Contract #: 04-0120F4Cty: SF/ALA Rte: 80 PM: 13.2/13.9File #: 69.25B**QUALITY ASSURANCE -- NON-CONFORMANCE REPORT****Location:** Changxing Island, Shanghai, P.R. China**Report No:** NCR-000436**Prime Contractor:** American Bridge/Fluor Enterprises, a JV**Date:** 10-Sep-2009**Submitting Contractor:** Zhenhua Port Machinery Company, Ltd (ZPMC), Changxing Island**NCR #:** ZPMC-0410**Type of problem:****Welding****Concrete****Other****Welding****Curing****Procedural****Bridge No:** 34-0006**Joint fit-up****Coating****Other****Component:** Segment 6BW Floorbeam Flange & Deck Diaphragm**Procedural****Procedural****Description:** Missed UT Indication by QC**Reference Description:** Missed UT indications by QC on Floorbeam Flange and Deck Diaphragm in 6BW**Description of Non-Conformance:**

Job Name: SAS Superstructure

Subject: NCR No. ZPMC-0410

Reference Description: Missed UT indications by QC on Floorbeam Flange and Deck Diaphragm in 6BW

SPANG
WELDING MAP
SEC 029
171

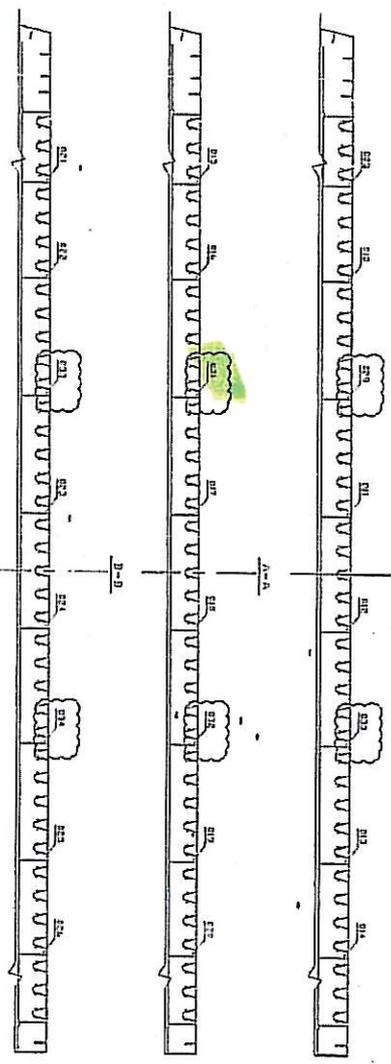
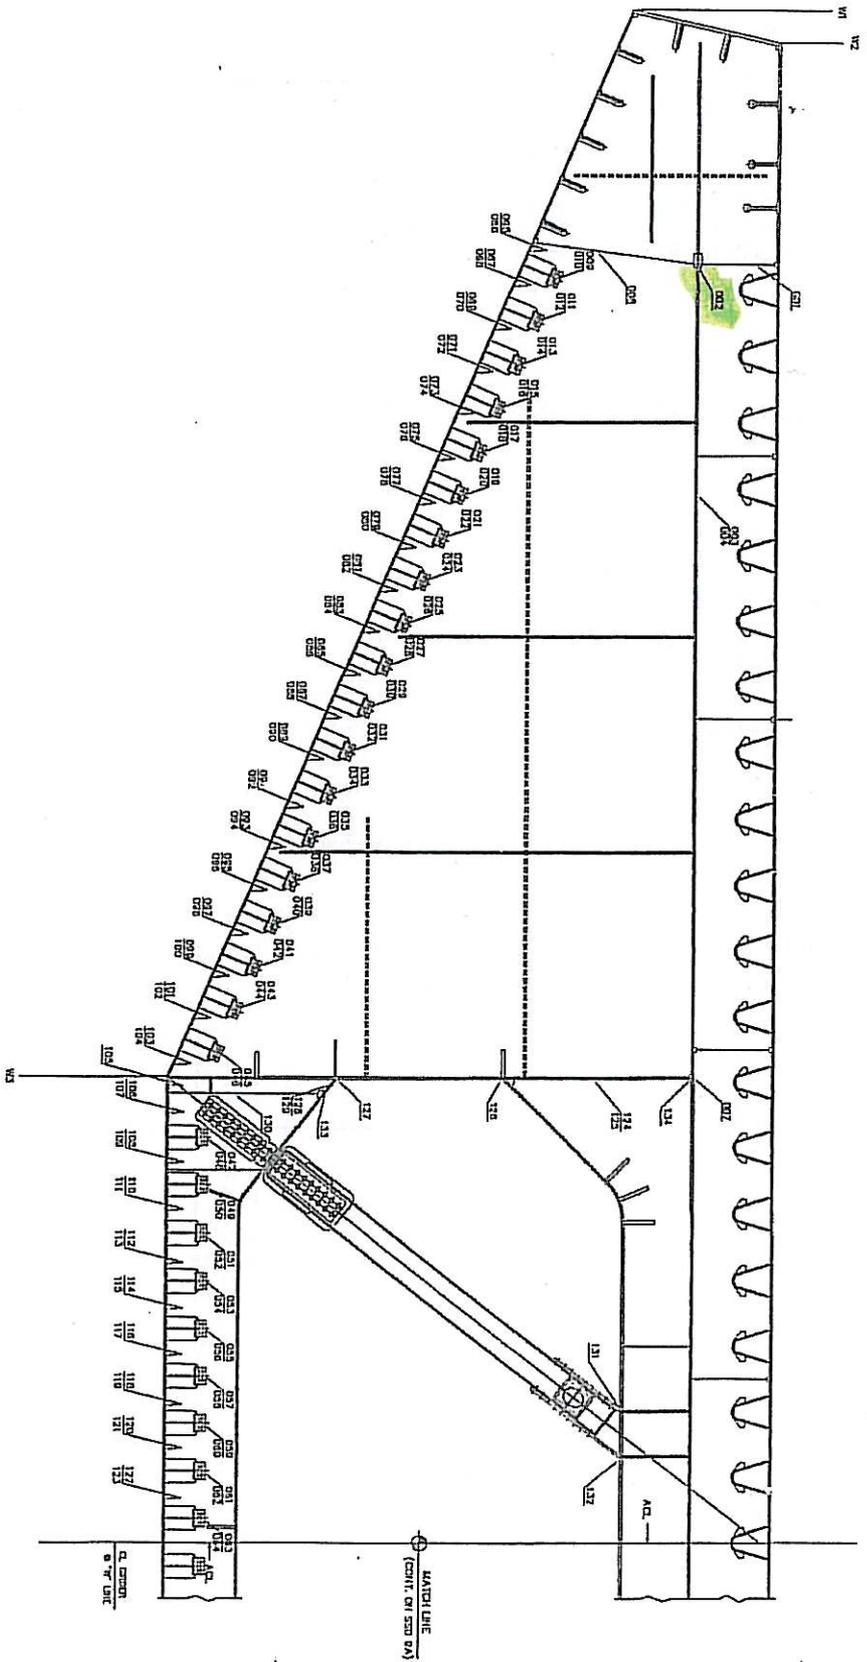
During random verification Ultrasonic Testing (UT) of the deck panel diaphragm splice weld and floor beam flange splice weld at panel point 42 (Segment 6BW), Caltrans Quality Assurance (QA) Inspector discovered a total of (2) two, rejectable defects of up to 30mm in length. The weld designations are as follows: SEG029*-031 (diaphragm splice) and SSD9-PP42-002 (flange splice). These welds have been previously tested and accepted by ZPMC Quality Control UT Technicians. Due to the amplitude and planar characteristics of the ultrasonic response in the deck panel diaphragm splice weld SSD9-PP42-002, this QA inspector carried out Magnetic Particle Testing (MT) on the excavation of the rejected weld and found a linear indication measured 20mm in length.

The welds referenced in the NCR have been repaired, tested and found acceptable by ABF, ZPMC and Caltrans. The acceptability of the welds was documented in QA Approval Form #11157 for weld joint SEG029*-031 and QA Approval Form #11160 for weld joint SSD9-PP042-002. These forms were signed after the non conformance was documented. Based on this ZPMC requests closure of this NCR.
